## Recall Repair Instructions

NHTSA Recall # 26V-342

Tiffin Recall # WAY-107

**Purpose:** Replace the Incorrect OCCC Label with the correct OCCC Label.

Figure 1

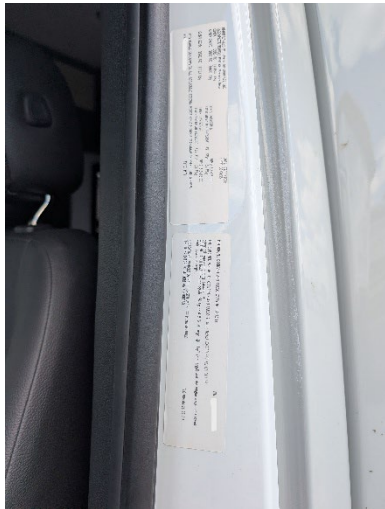
1. The incorrect white Cargo Carrying Capacity Label can be found on the driver's side door panel, see Figure 1. The label can be left in the current position.
2. Clean a clear area of the passenger's side door jamb with isopropyl alcohol and carefully place the new label in a clear area of the door jamb. DO NOT cover up the yellow label already installed as it has different information listed.
